CITY OF FORT COLLINS

ADDENDUM No. 2

BID #5681

FOSSIL CREEK COMMUNITY PARK

**WOODEN BRIDGE PLAN**  
**FOSSIL CREEK COMM. PARK**  
**JOB NO. 39262.00**  
**3/14/02**  
**1 OF 5**

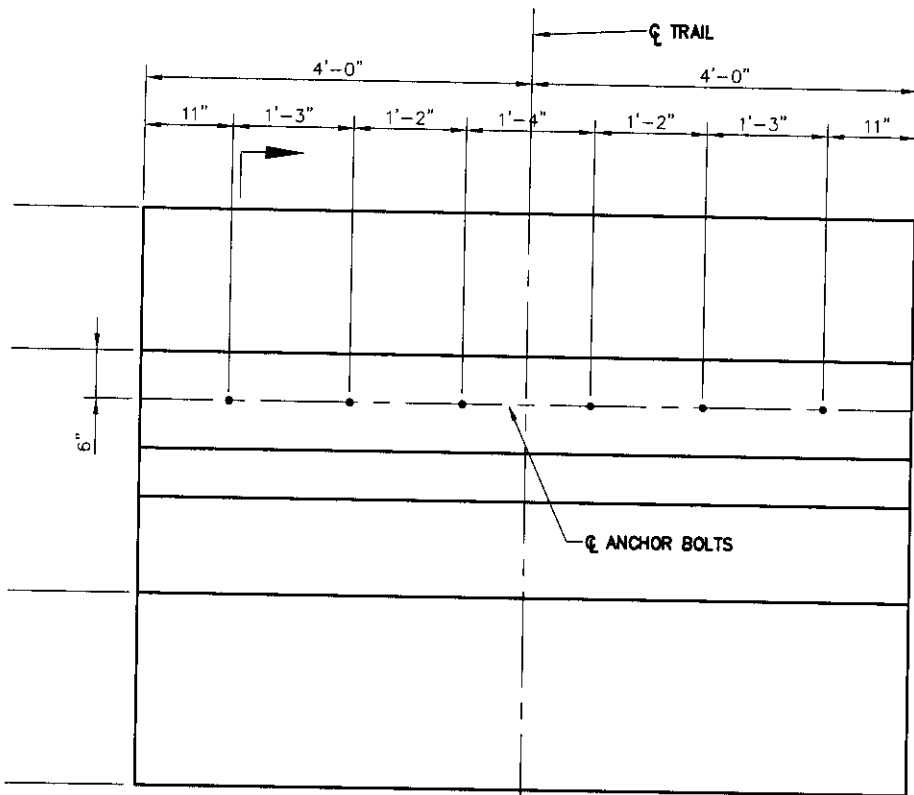
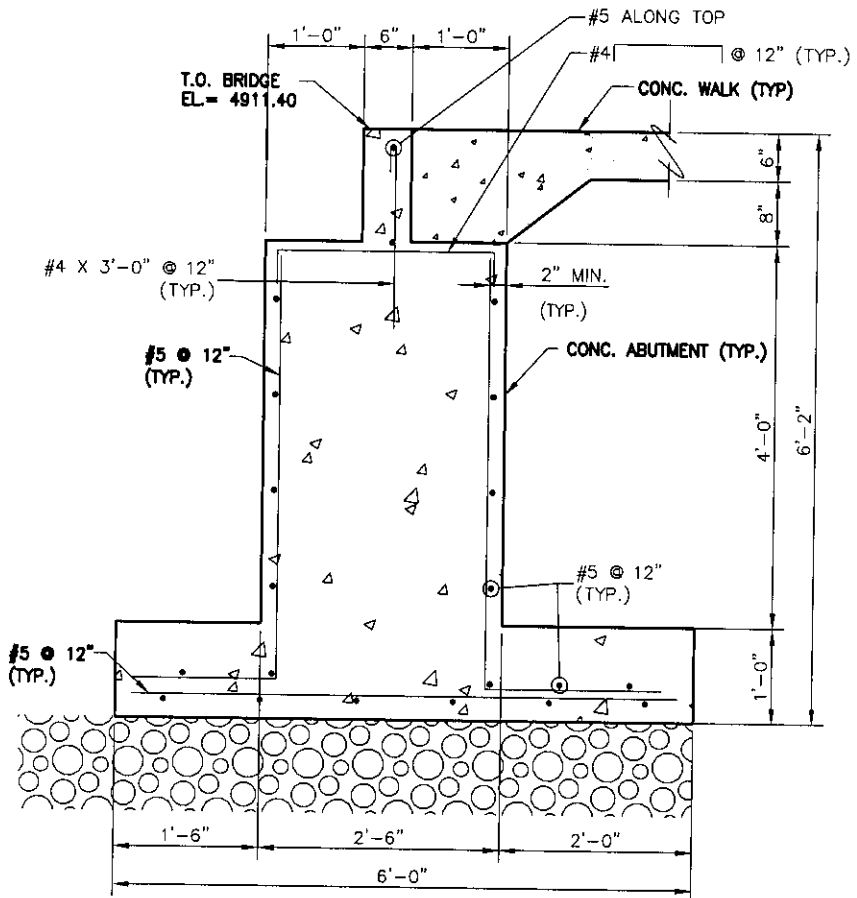
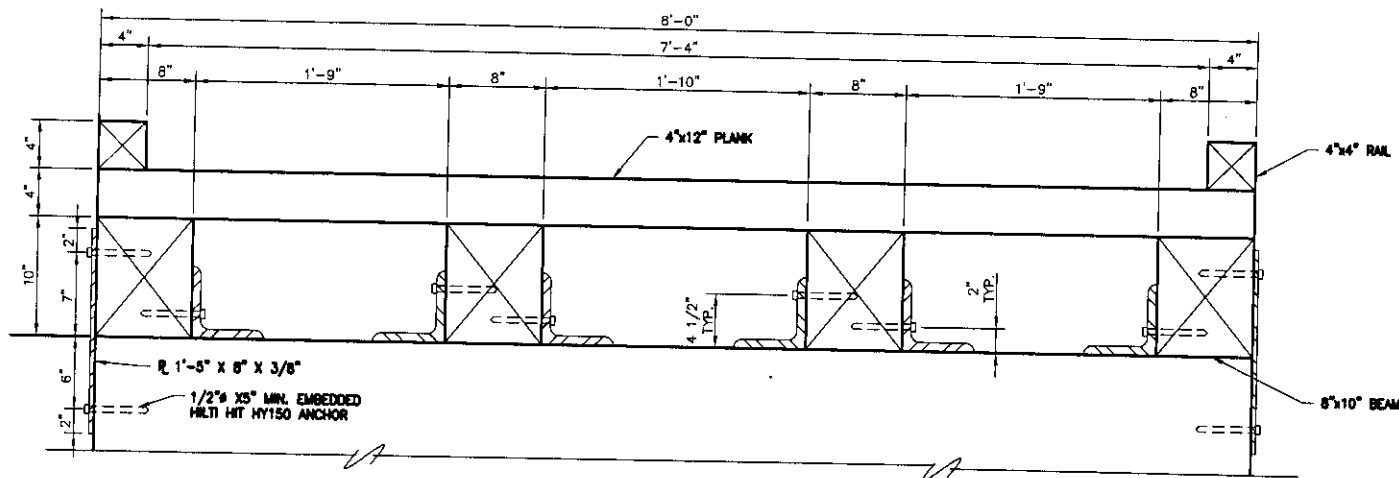
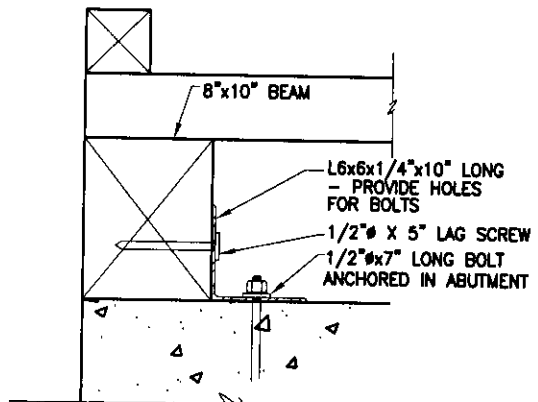
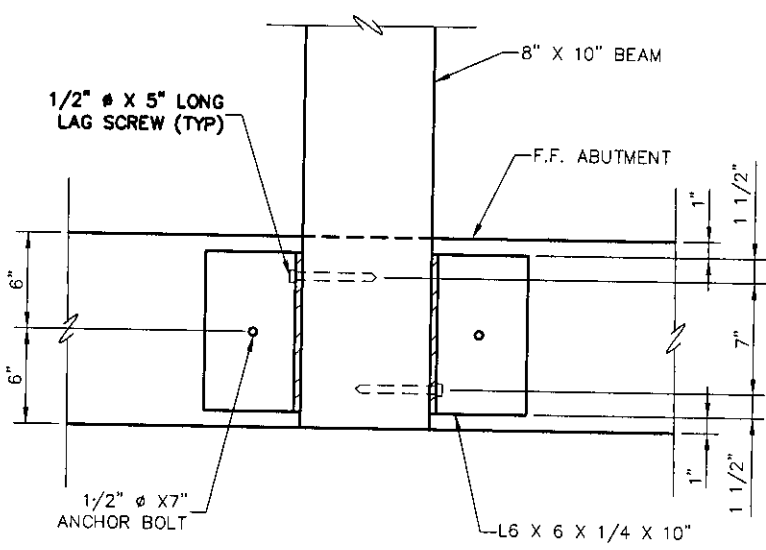
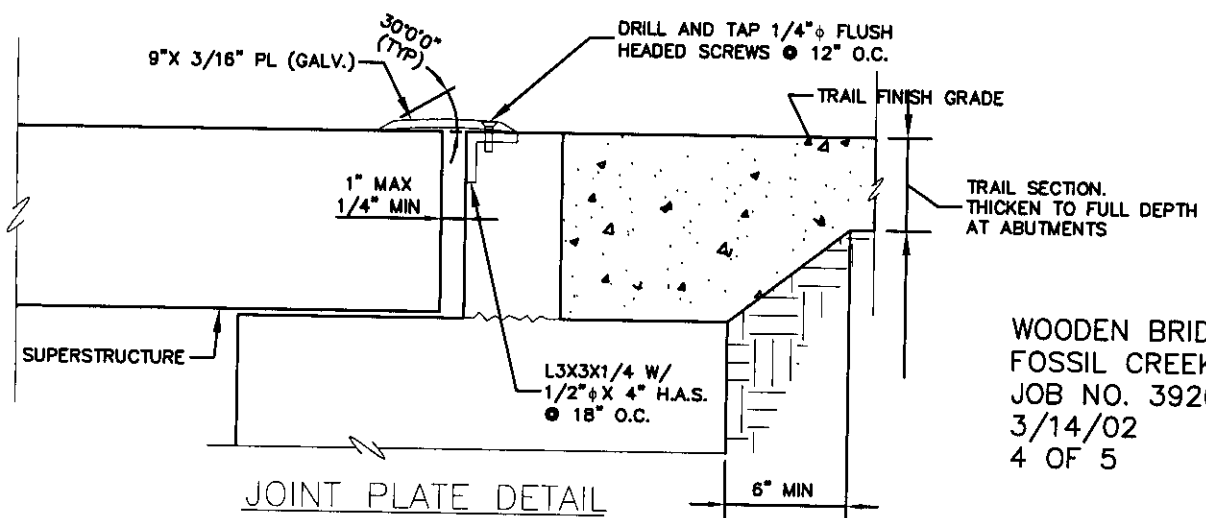
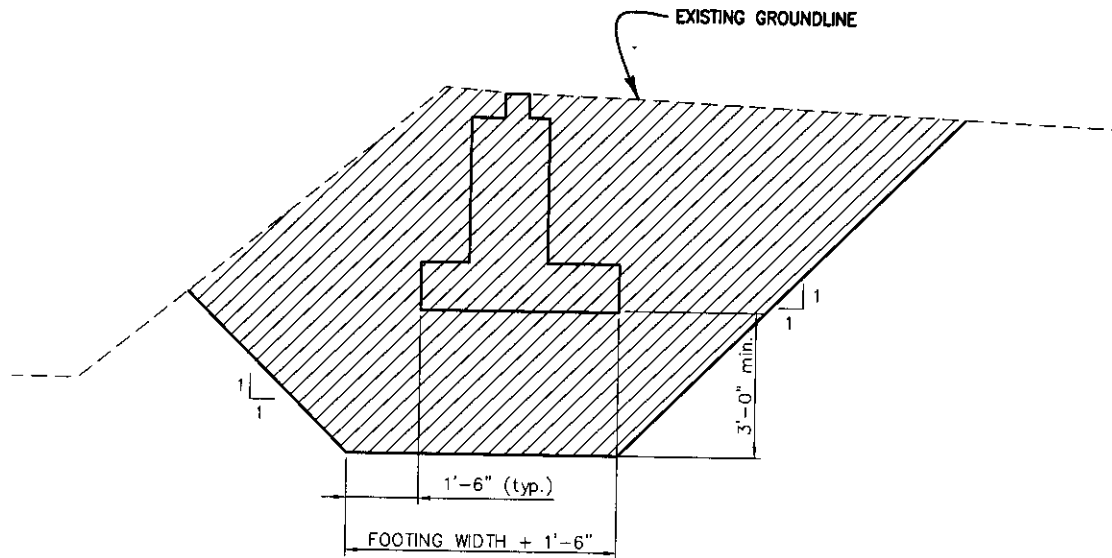
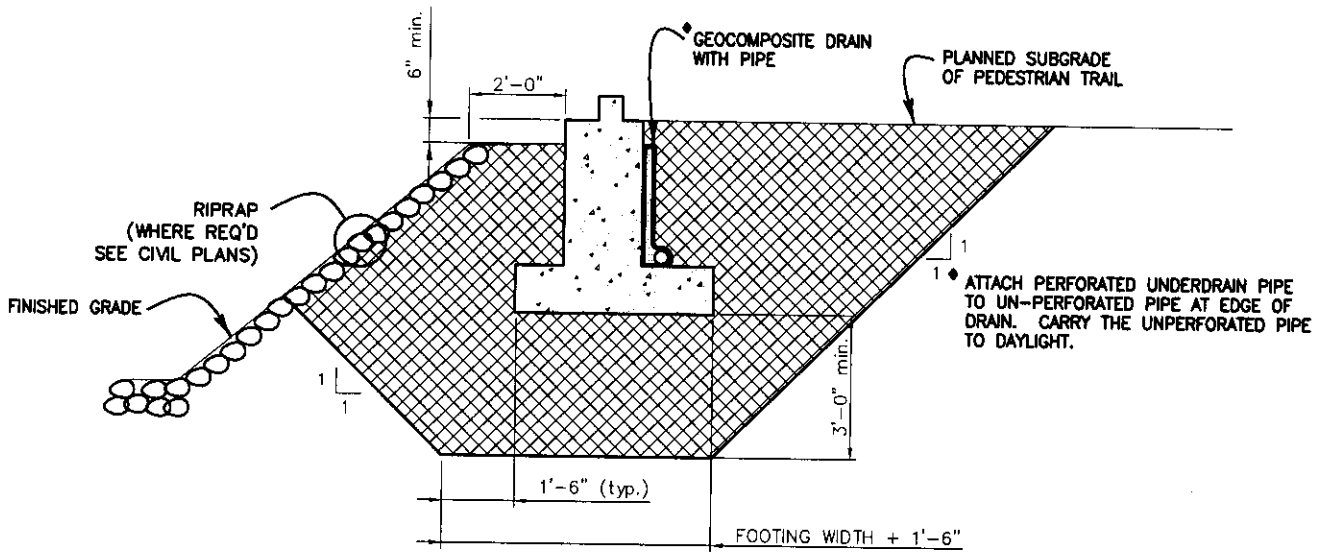
1. Wooden Bridge Plan and Details (sheet after D20.3 and before D21.1), This drawing sheet shall be replaced by the five attached 8.5 x 11 sheets
2. Sheets D21.1 and D21.2, The General Notes on these sheets apply to the concrete bridge abutments only. Refer to specification section 02890 for information regarding the bridges.
3. Sheet D4.5, Detail 1, The top rail of the chainlink fence shall be 1.625" outside diameter (not 1.875").
4. Sheets P4, P6 and P14, Unless otherwise noted, the edger around the planting beds on these sheets shall be 6" Concrete Edger.
